Appendix 2: Internal Referral Responses

I.1 Internal referrals

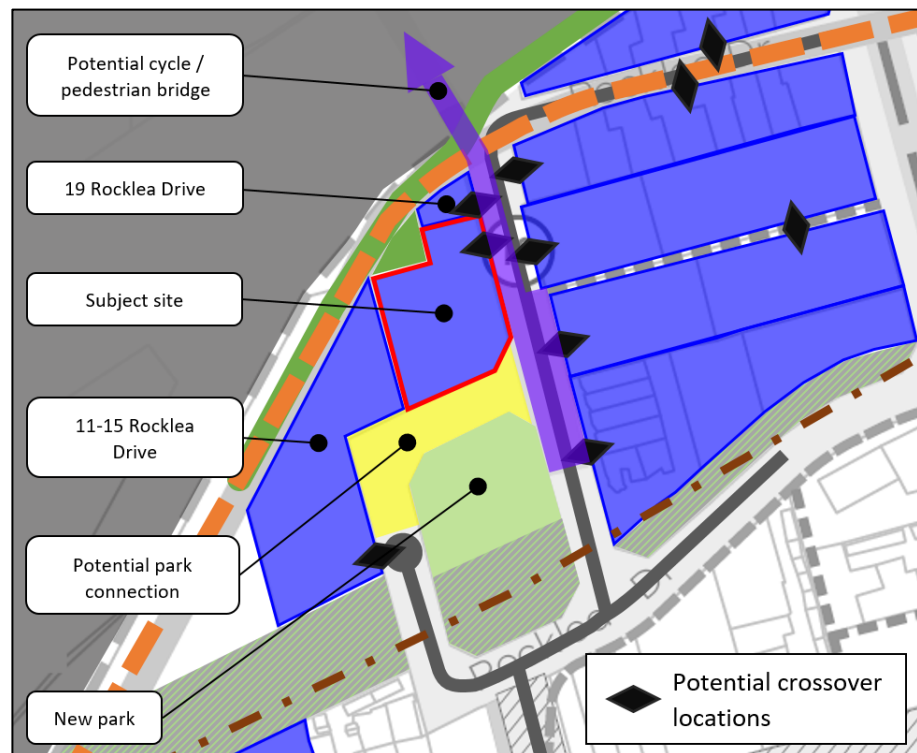
- The proposed car parking numbers are significantly higher than the maximum permitted for this site under PO1 (currently 149 spaces proposed compared with 113 spaces permitted). Based on the current proposal plans, this 36-space excess is the equivalent to one level of podium parking – this floor area could be better utilised to reconfigure the podium to create a built form that better responds to the preferred building typology and character of the area.
- The location of vehicle access via the existing crossover at the southwest corner of the site is consistent with DDO33. Relocation of this access, however, to the northeast corner of the site (northern end of the Rocklea Drive frontage) should be explored. As illustrated in the diagram below, if there are no vehicle access points on

the abutting east-west section of Rocklea Drive (both the subject site and 11-15 Rocklea Drive), there is potential to expand the new park across this road reserve. This outcome will provide a better interface to the park. This outcome will provide the following benefits:

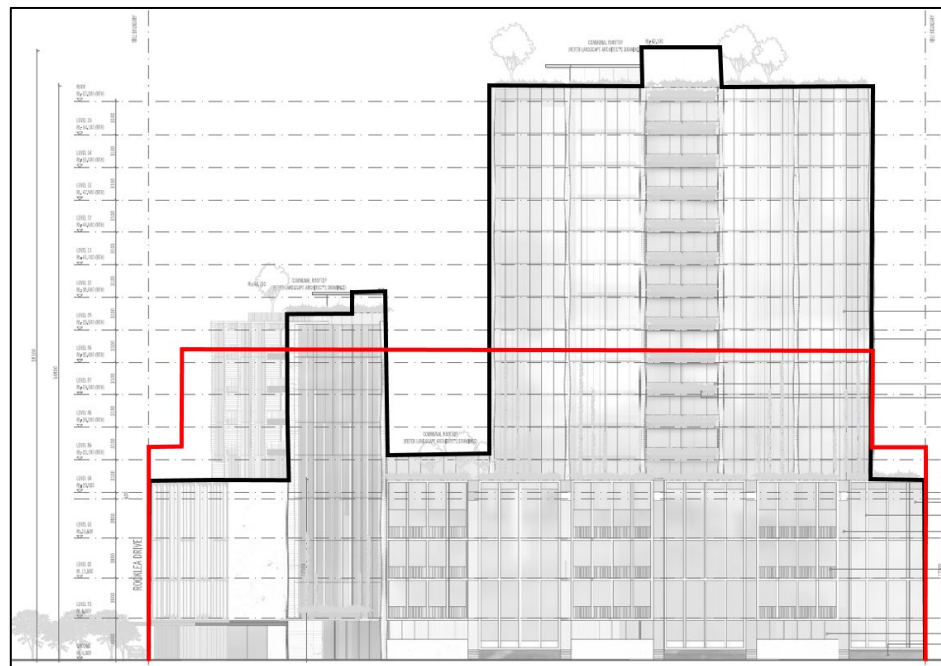
- The proposed building height is a maximum 58.1m (top of the core overrun of the northern tower). The core overrun is included in height calculations, as it is not set back at least 3m behind the building façade, as required in Clause 2.5 of DDO33. The communal lounge on the roof of the northern tower is considered a storey, so the northern tower is 17 storeys. The southern tower has a maximum height of ten storeys and 36.7m.
- The maximum building height for Area W1 is eight storeys / 30m (refer to diagram below). Both the northern and southern towers are higher the preferred building

height by nine storeys / 28.1m and two storeys / 6.7m respectively (as illustrated in the diagram overleaf). This is a substantial exceedance. Under the definition of mid- and high-rise in Clause 2.4 of DDO33, the proposal is high-rise and is not consistent with DDO33.

Level 4

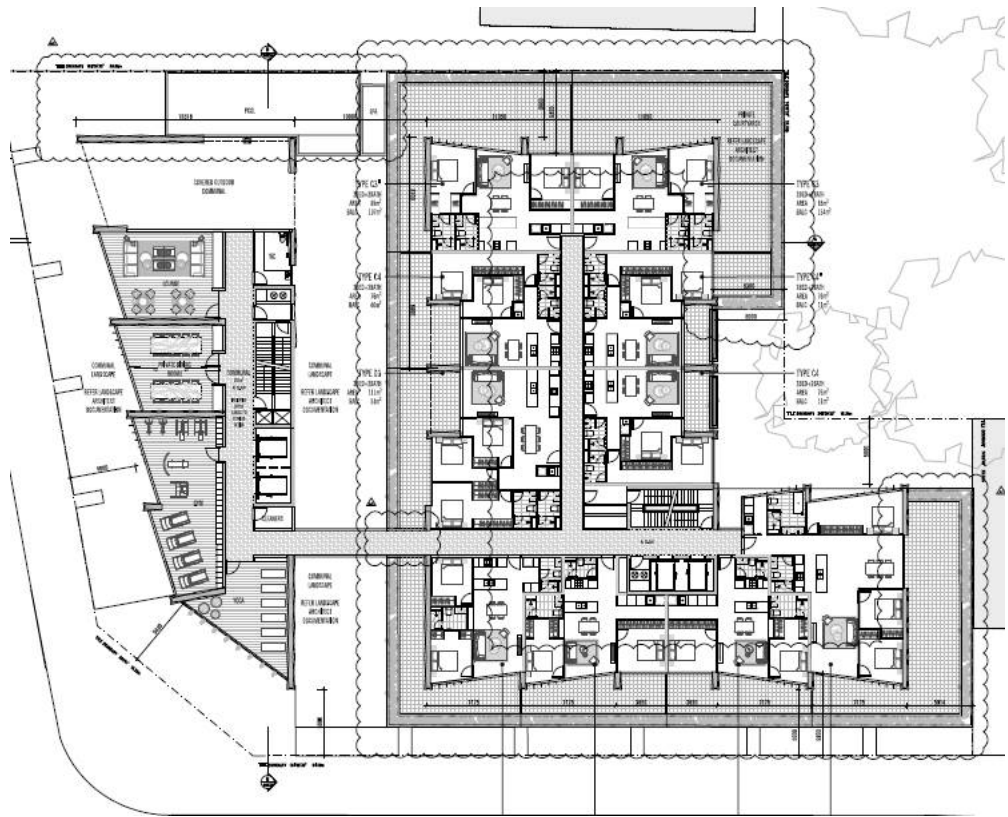
The architectural features shown in the landscape plans don't match on Level 4, example below:

The south side (right side) of the building shows a large patio area with planting along the edge. This is not included in the landscape plans.
